Amendments to the Drawings:

REMARKS/ARGUMENTS

Changes in the Drawings:

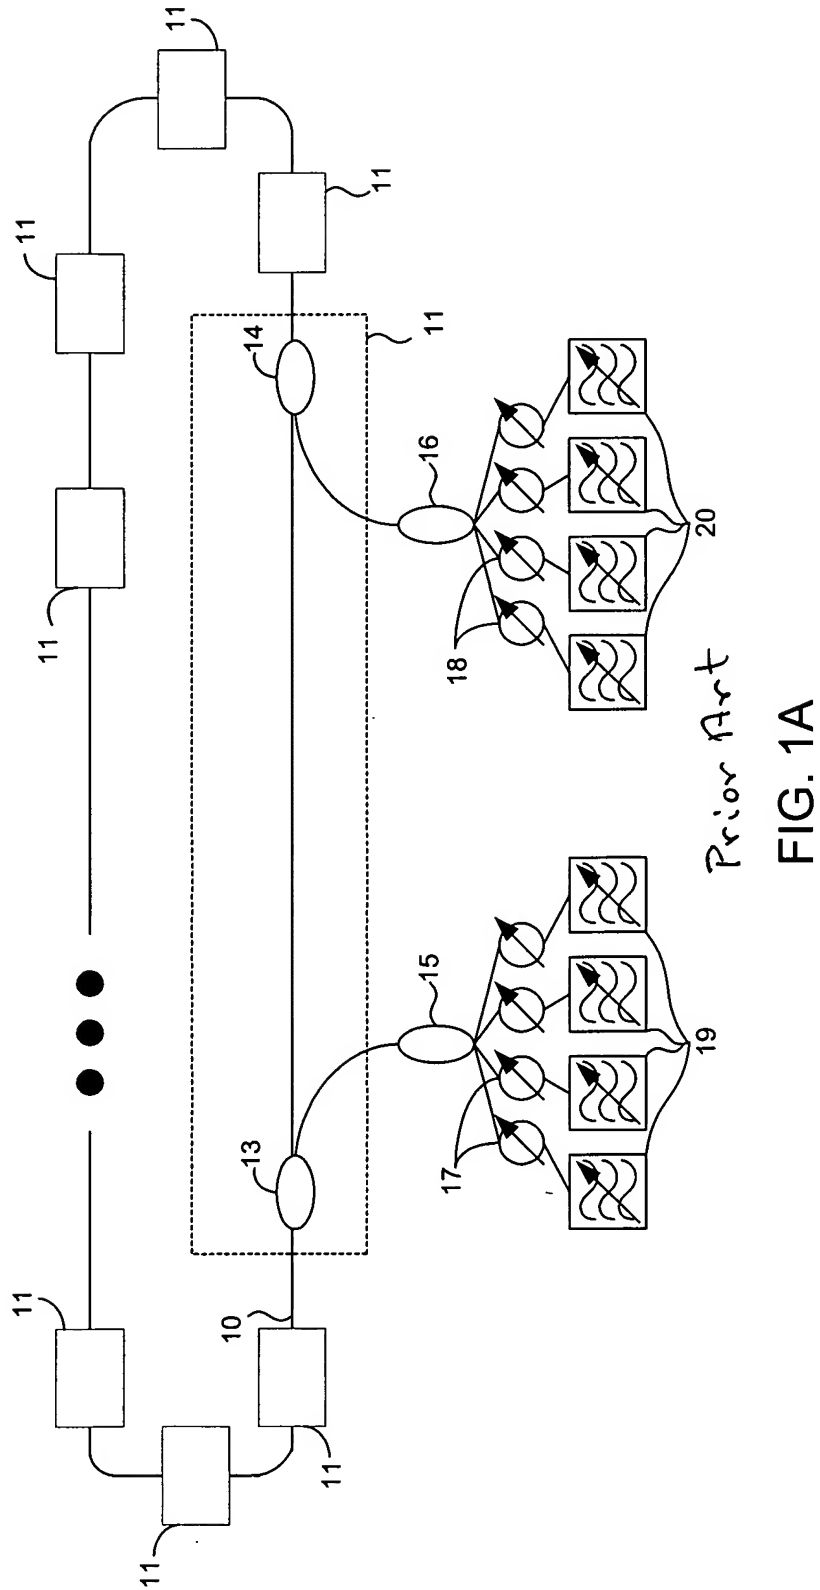
“FIG. 1A” has the phrase, “Prior Art” inserted therein.

FIG. 1B

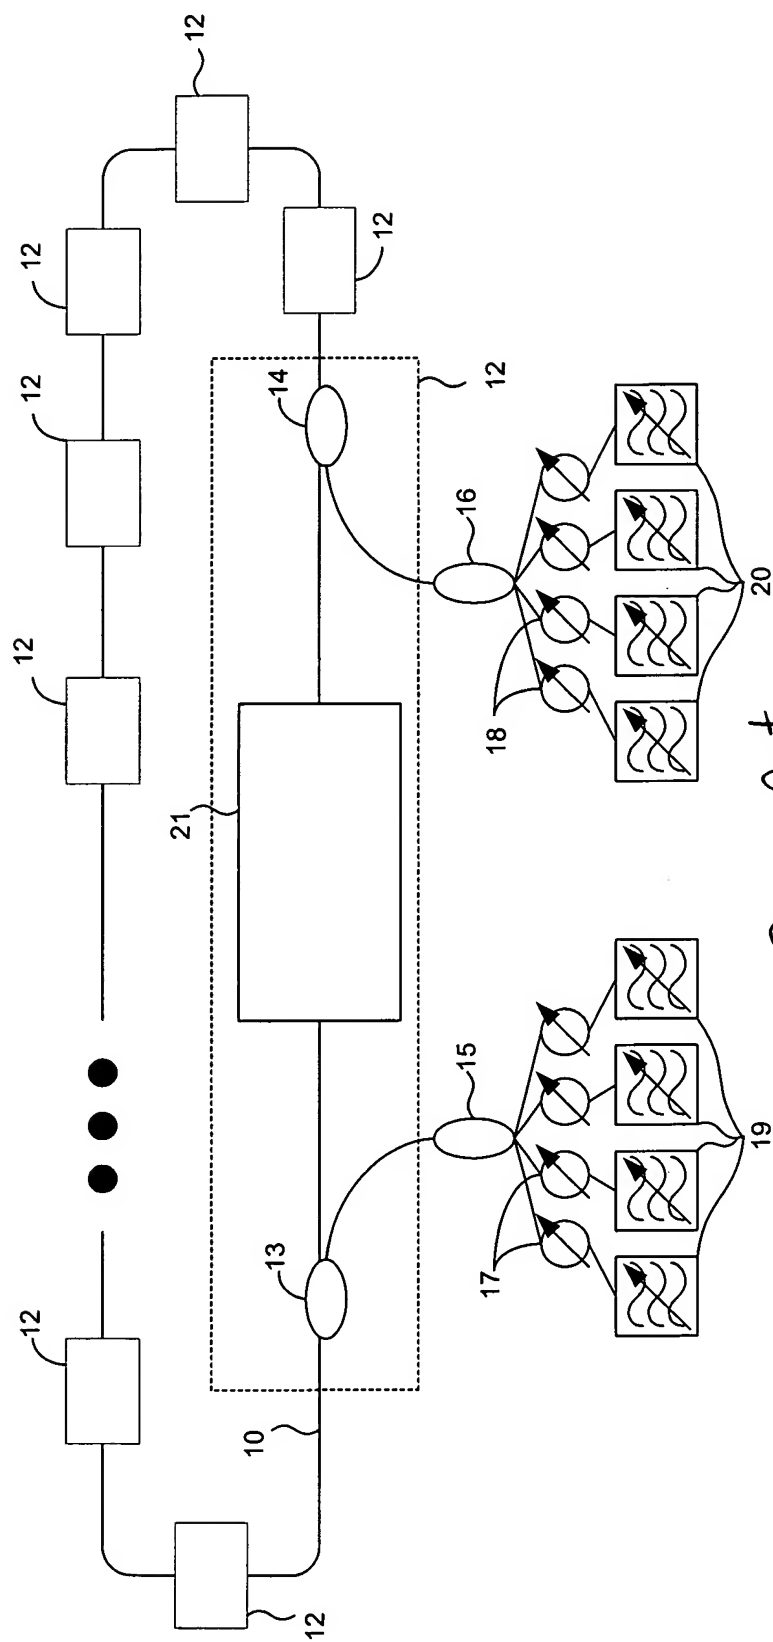
“FIG. 1B” has the phrase, “Prior Art” inserted therein.

FIG. 23

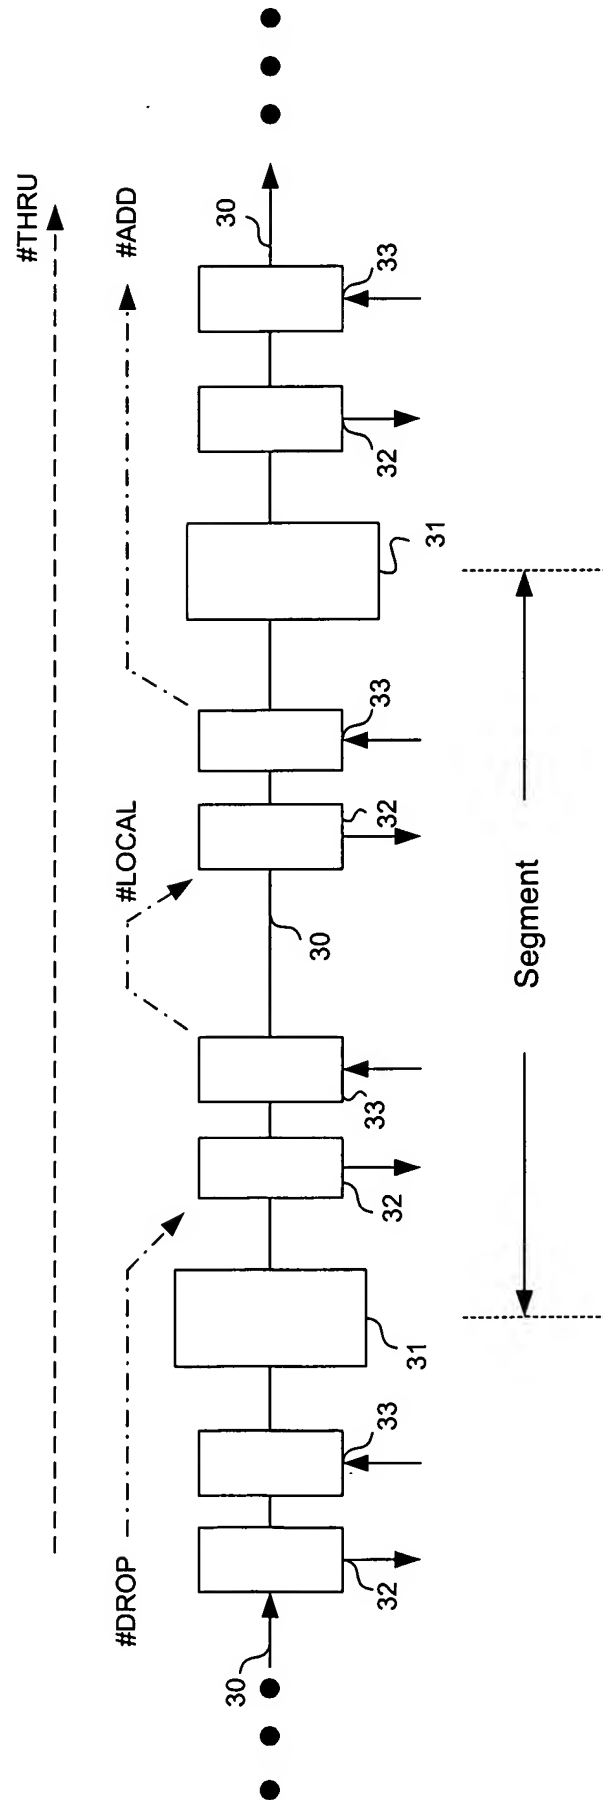
“FIG. 2” has been relabeled “FIG. 3”.

“FIG. 3” has been relabeled “FIG. 2”.

FIG. 5A-4A

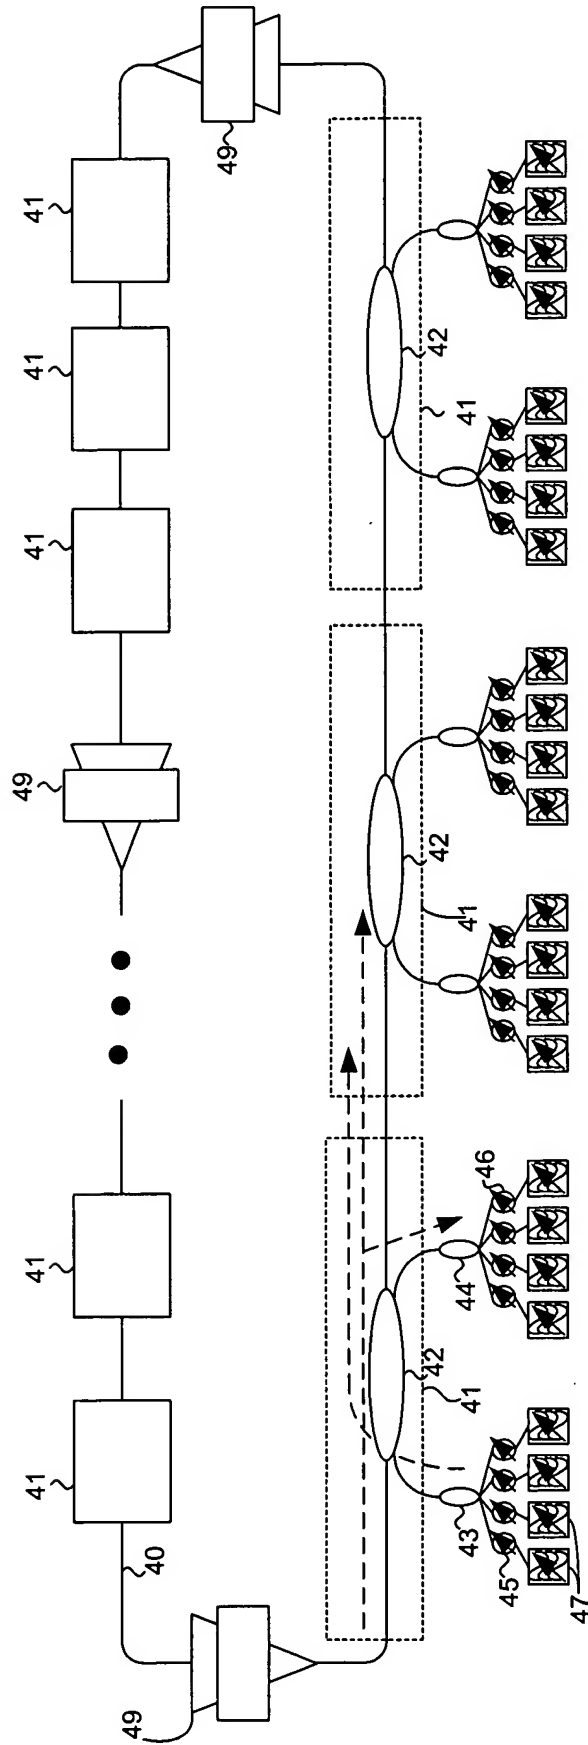
“FIG. 5A” has been relabeled “FIG. 4A”.

FIG. 5B 4B

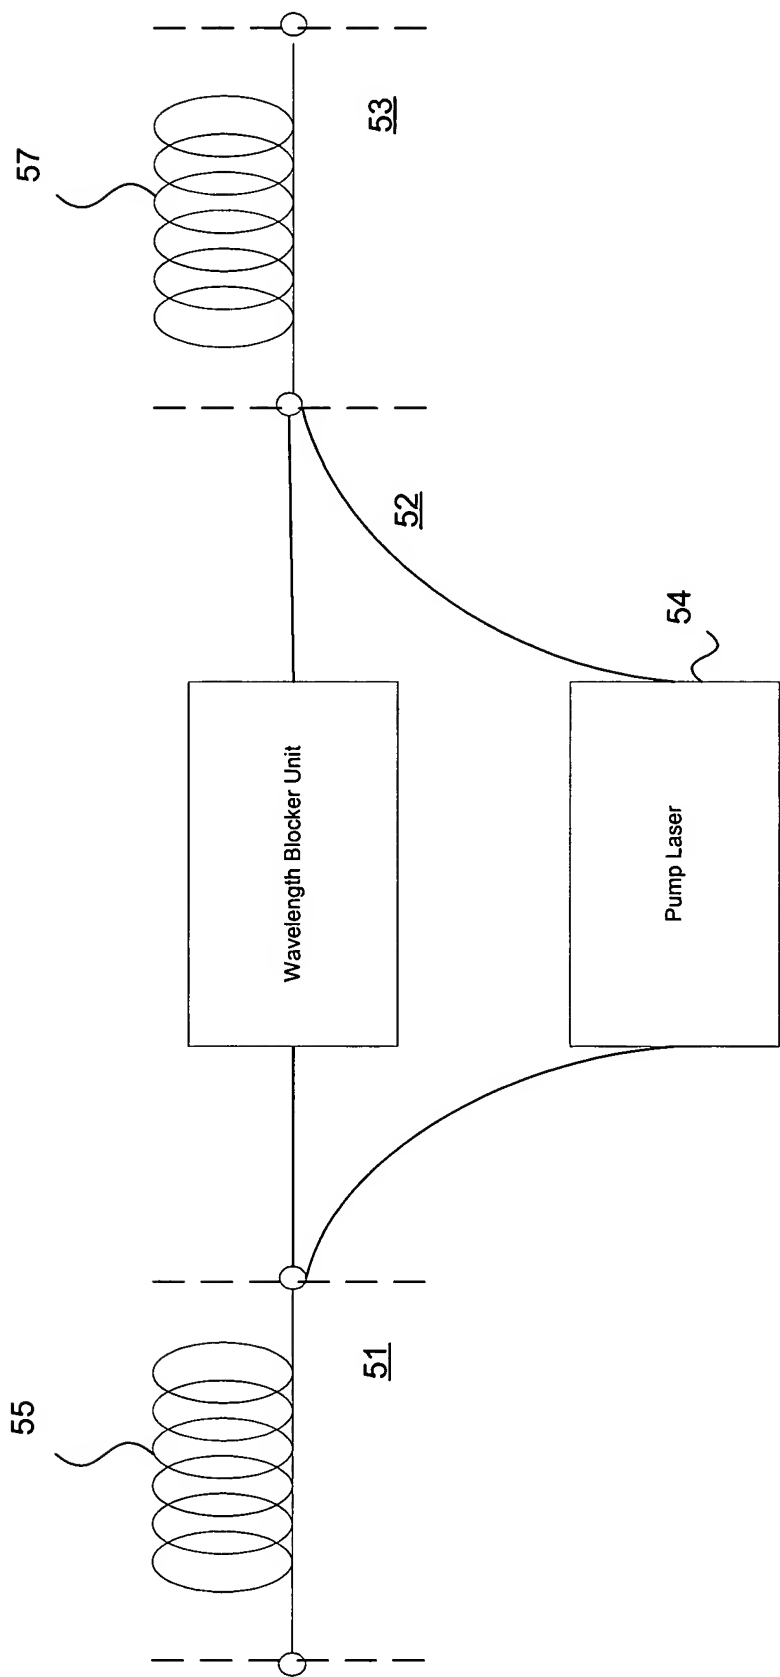
“FIG. 5B” has been relabeled “FIG. 4B”.

FIG. 5

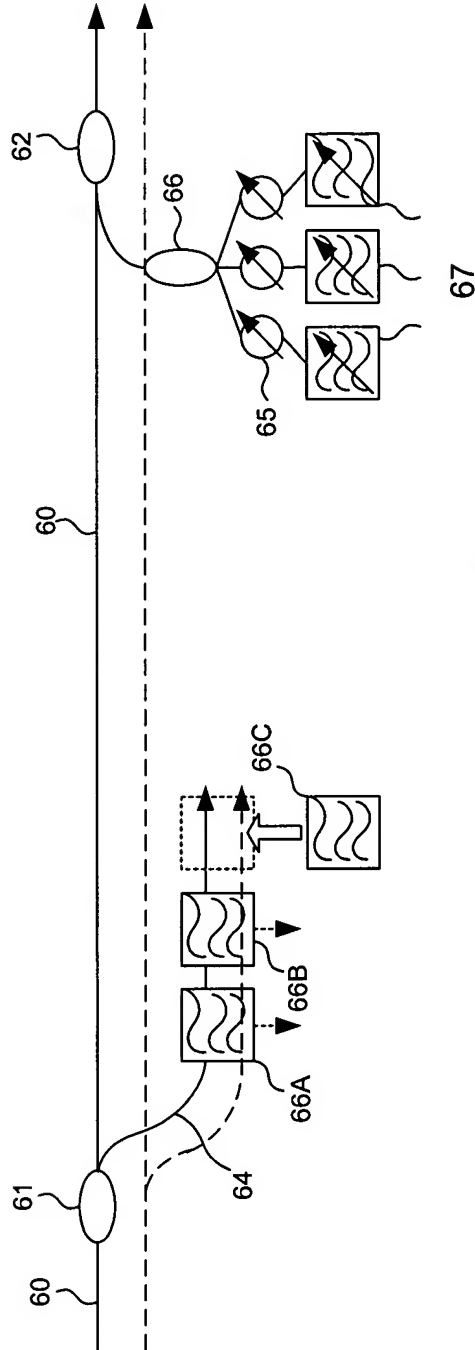
“FIG. 6” has been relabeled “FIG. 5”.

Fig. 4A

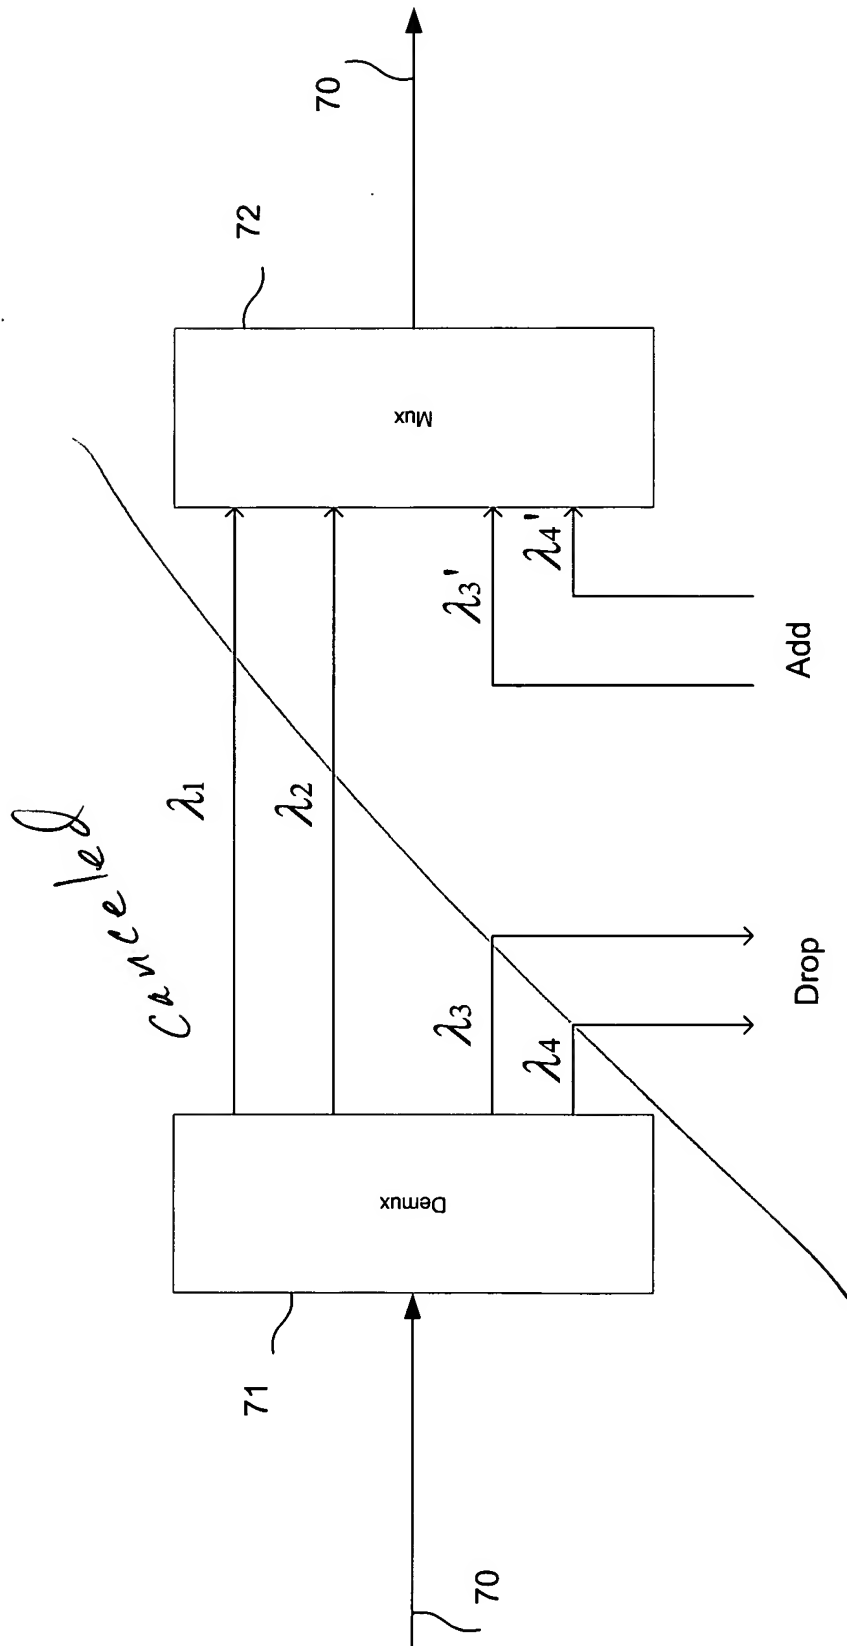
“FIG. 4A” has been canceled.

Fig. 4B

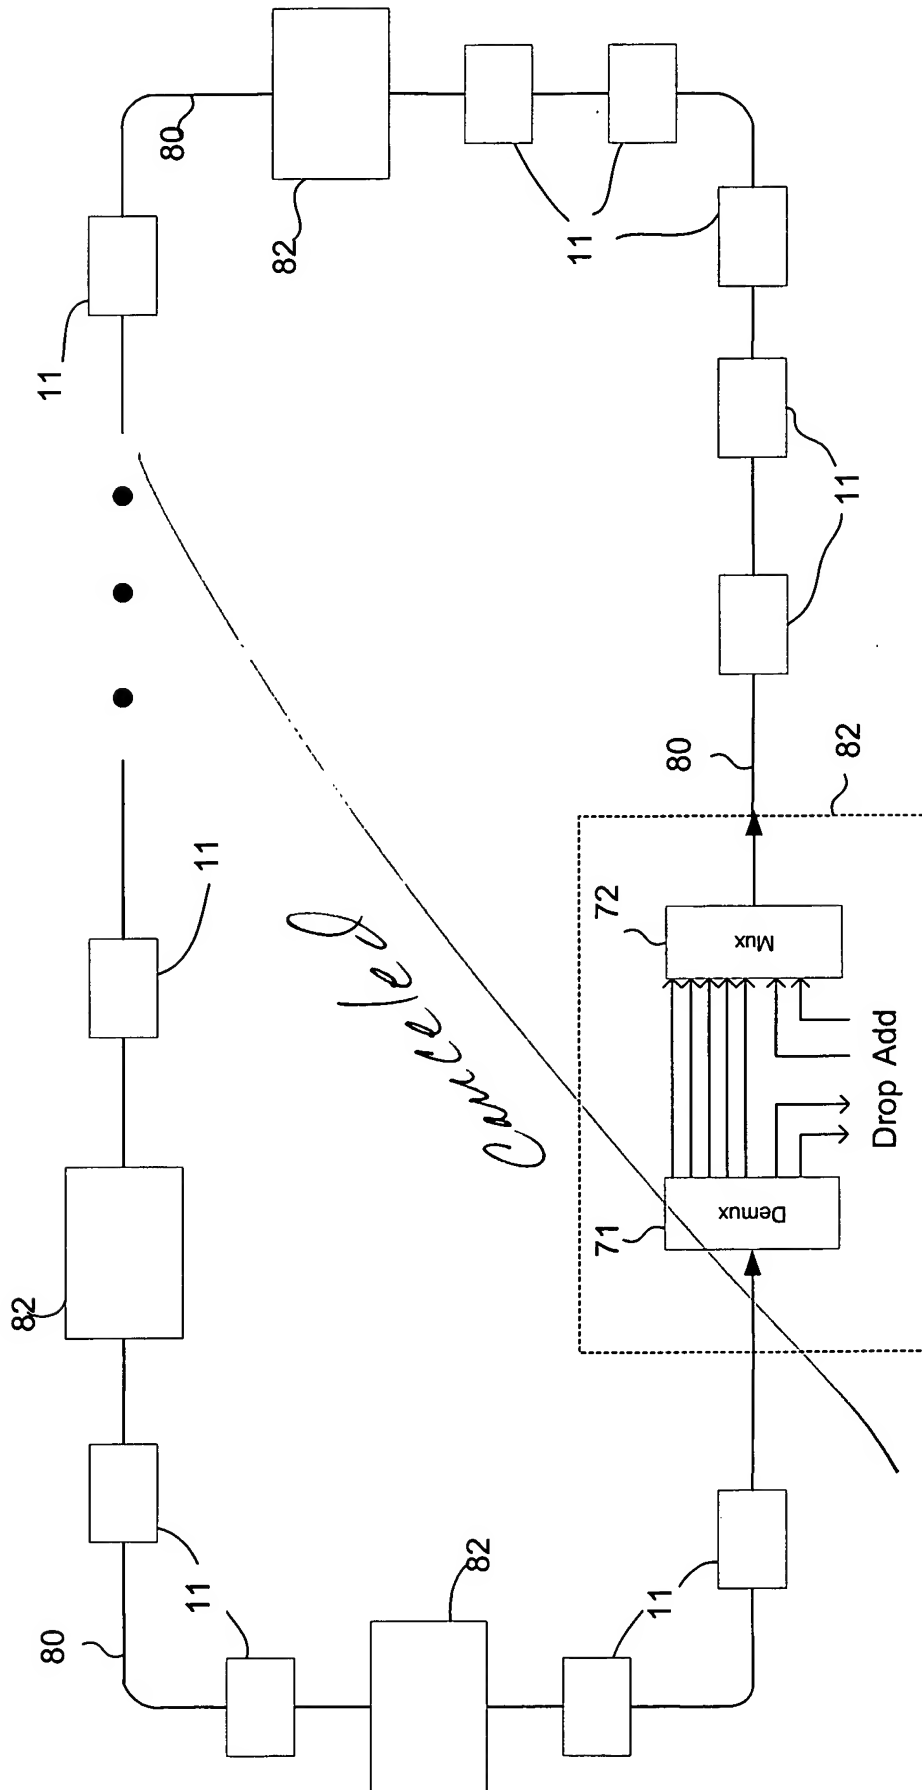
“FIG. 4B” has been canceled.
